NEUTRON PRODUCTS inc

20 August 2001

This letter is in timely response to your letter dated July 26, 2001 which arrived here on July 30.

FIGURE 3

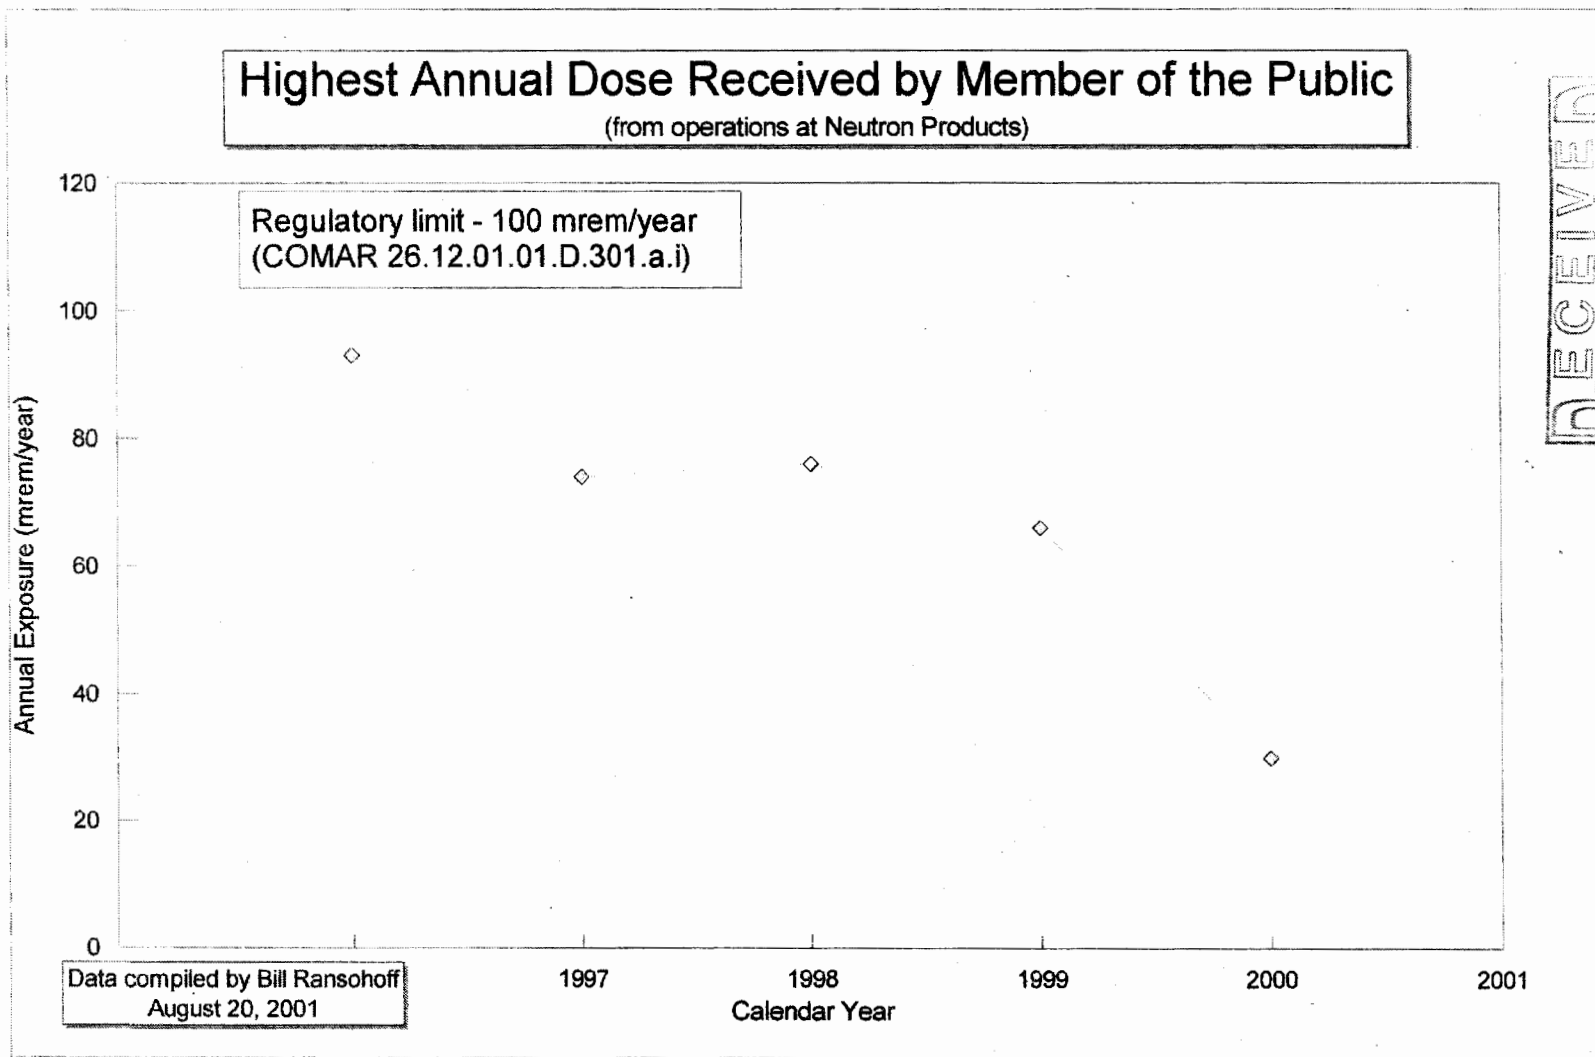
7.2 In fact, such an evaluation was performed and included in Figure 3 of Neutron's letter to MDE dated February 12, 2001, which estimates the dose to the most highly exposed member of the public for the year 2000 to have been 43 mrem, if he had resided in the house at issue for the entire year, which he did not. So, as of February 12, MDE was aware that Neutron had performed the necessary calculations to demonstrate that it was in compliance with the annual dose limit as described in Section D.301 for the calendar year of 2000.

FIGURE 2

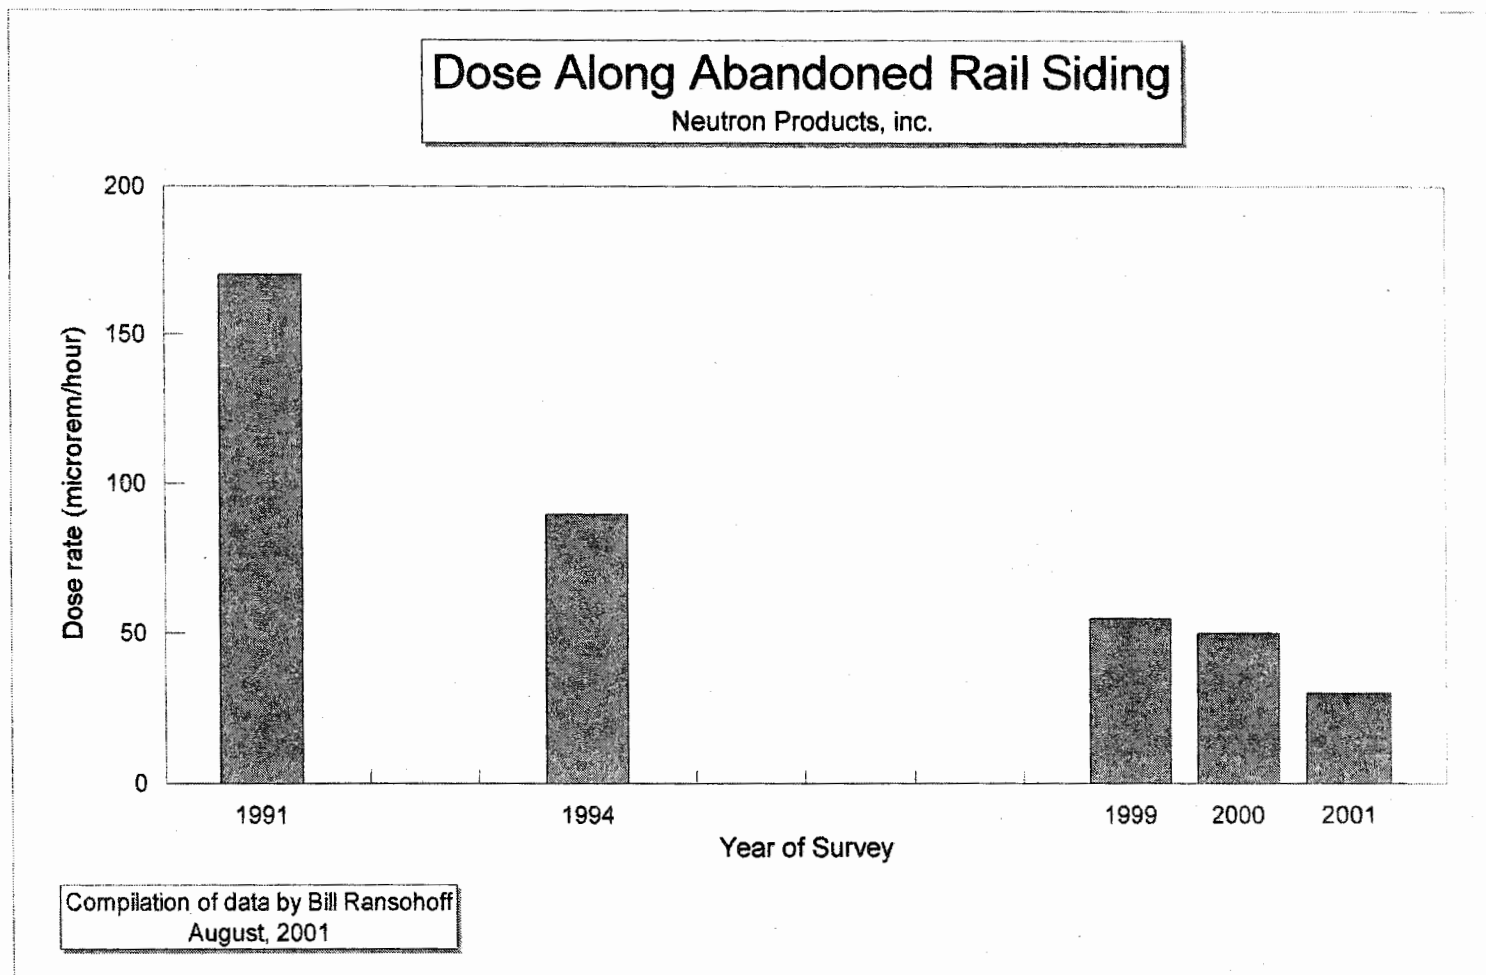
1.11 Over the years, all of these efforts have proven effective in reducing the dose rates along the referenced rail siding, as is depicted graphically in Figure 2. Jeffrey Williams and Bill Ransohoff will be responsible for ensuring that these corrective action efforts continue.
